Access Compliance Report Public Rights-of-Way (Curb Ramps)

Main Street: **SPRING_ST** Cross Street: **S_ESPLANADE_ST** Location: **SE**

ADA ID: **RPAT210927113744** Ramp Type: **Type 4 - Parallel** Initial Pass/Fail: **Pass** Overall Compliance: **No** Severity Score: **0**

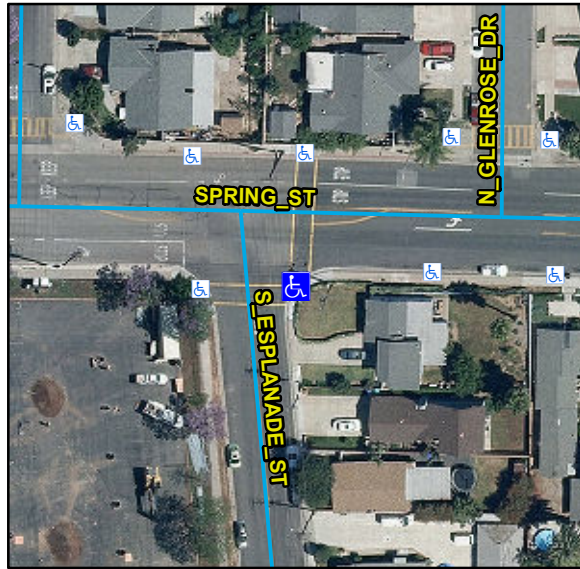
Yes	Ramp Inside Crosswalk 1	Yes	Yes	Ramp Inside Crosswalk 2	Yes
	Crossing 1 Slope (%)	5.3		Crossing 2 Slope (%)	3.5
	Crossing 1 Cross Slope (%)	0.9		Crossing 2 Cross Slope (%)	1.1
Yes	Gutter Ponding	No	No	Curb Slope	9.4
Yes	Gutter Lip Height (in)	0		Road Run Slope (%)	1.3
Yes	Gutter Run Slope (%)	4.7		Road Cross Slope (%)	5.1
Yes	Gutter Cross Slope (%)	1.2	Yes	Perpendicular Joint Present	Yes
Yes	Overall Surface Condition	Acceptable			
	Cross Gutter Present?	No		Spandrel Present?	No
	Replace Cross Gutter?	N/A		Replace Spandrel?	N/A

Remove & Replace Curb Slope.

R304.2.2, STD 1115
